Manual Supplement

Manual Title:	741B/743B Users	Supplement Issue:	7
Part Number:	644788	Issue Date:	12/09
Print Date:	June 1997	Page Count:	6
Revision/Date:	1, 3/98

This supplement contains information necessary to ensure the accuracy of the above manual.

Figure 1. Standard Equipment (cont.)

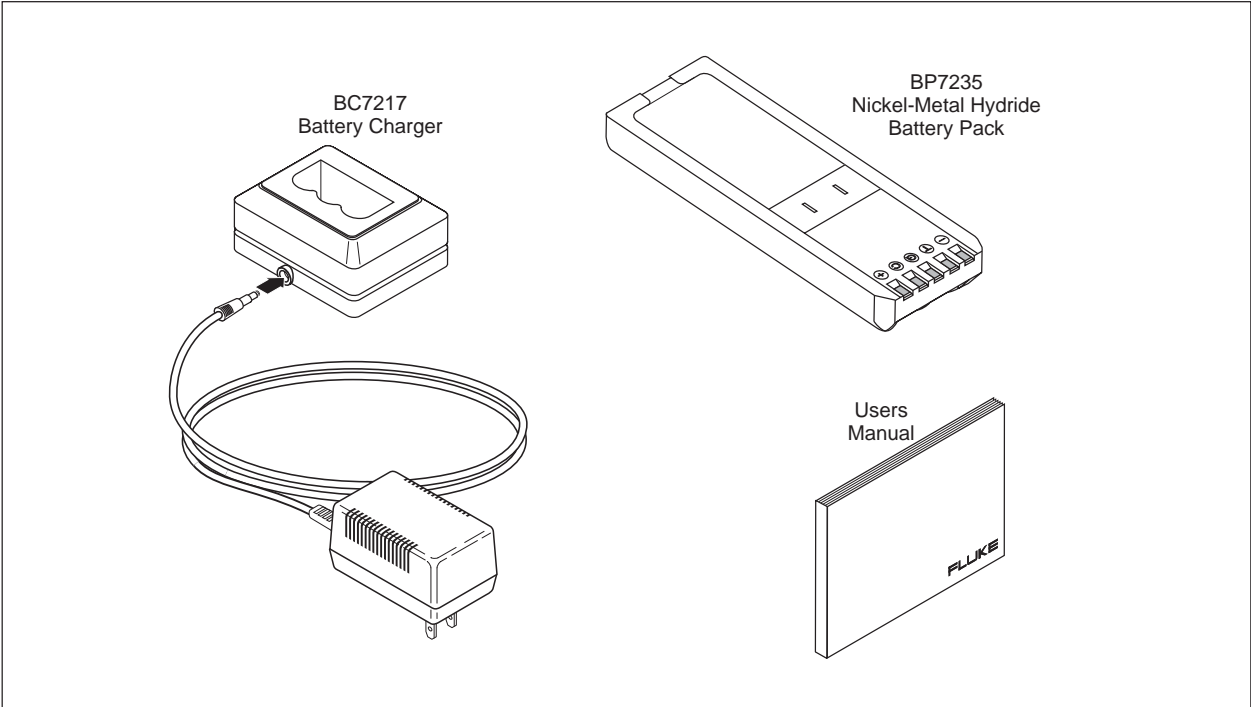
On page 6, replace Figure 1, with the following:
